Submission: 27-29 Tryon Road, Lindfield NSW 2070

State Significant Development

I am writing in relation to the proposed State Significant Development application SSD-78669234 – Residential flat building with in-fill affordable housing – 27-29 Tryon Road, Lindfield. This building falls within the LGA I reside in, and I request that the concerns in this submission alongside other similar submissions will be considered and addressed to ensure a more than optimal outcome for the local community and the environment.

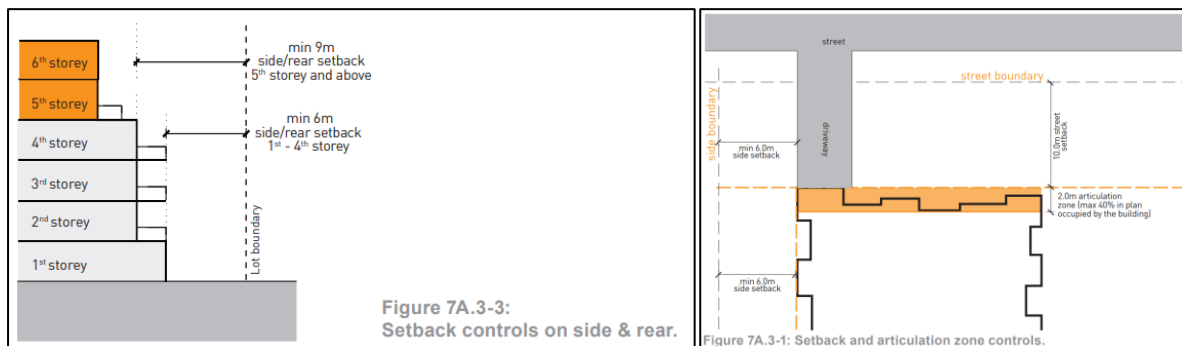
The inefficient and large basement with two different footprints results in limited space for deep soil. Additionally, tandem parking is an inefficient layout that increases the number of parking spaces and the footprint of the basement, for minimal advantage. It is unknown why the deep soil percentage stated on the image is not consistent with other figures.

The excessive amount of parking reduces potential deep soil.

- Rearrange the basement of the building to reduce its footprint. This may require reducing the number of parking spaces to achieve this or constructing an additional level below.

- Ensure that almost all the space within the building setback is utilised as deep soil. This is possible provided that the footprint of the basement is reduced.

- Ensure that the total amount of ADG compliant deep soil satisfies the minimum 15% required by the TOD SEPP and increase the amount of deep soil to the minimum 50% required by the KDCP, or at least as close to the minimum as possible. The adjacent 5 storey building has a similar site coverage but achieved the 50% deep soil area required by the DCP, so this should not be completely unfeasible.

The minimum setbacks stated on Part 14 of the Ku-ring-gai Development Control Plan.

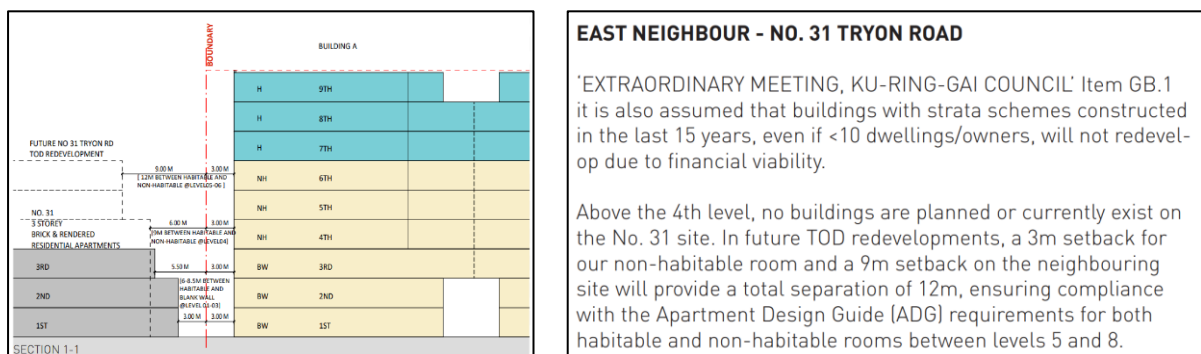
The 6m front setback and the 3m side setbacks are less than optimal for a building this size. In Ku-ring-gai Council, residential flat buildings constructed in the past have adhered to the minimum 10m front setback and 6-9m side setbacks stated on the KDCP. This practice allows increased deep soil, tree canopy cover, and vegetation to surround the building, encouraging the important environmental benefits stated in the above point, alongside providing residents with optimal views to nature and increased privacy. Additionally, the generous front setback allows the uniquely high-density building in the lower-density surrounding environment to share a similar character alongside older development or previous residential flat buildings regulated by the KDCP. This includes the tall, large trees and the open, blue sky associated with Ku-ring-gai.

However, the current proposed setbacks do not facilitate any of these benefits or qualities. The 6m setback may align similarly with adjacent developments, but at 9 storeys the proposed building is significantly taller than its 5 and 3 storey neighbours. Neither of these developments are likely to be upzoned, demolished, and rebuilt for many years due to financial viability and costs. The justification provided for the 3m side setbacks is that the responsibility of maintaining adequate building separation required by the NSW Apartment Design Guide should be passed to the future development, and that the future adjacent building must increase their setback to accommodate for this. This justification is questionable as it unfairly impacts adjacent sites.

- Increase the front setback from 6 to 10m to allow for increased deep soil and to maintain the surrounding character for the reasons provided above. If the rare instance that 10m is deemed to be completely unfeasible, please increase the setback as much as possible to the target distance.
- Increase the side setback enough to ensure adjacent sites will not be required to increase the setback of future buildings more than the minimum requirements.
- Increase the building height from 9 storeys to accommodate for the loss in floor area due to the additional setbacks. This may result in a building height of 10-12 storeys.
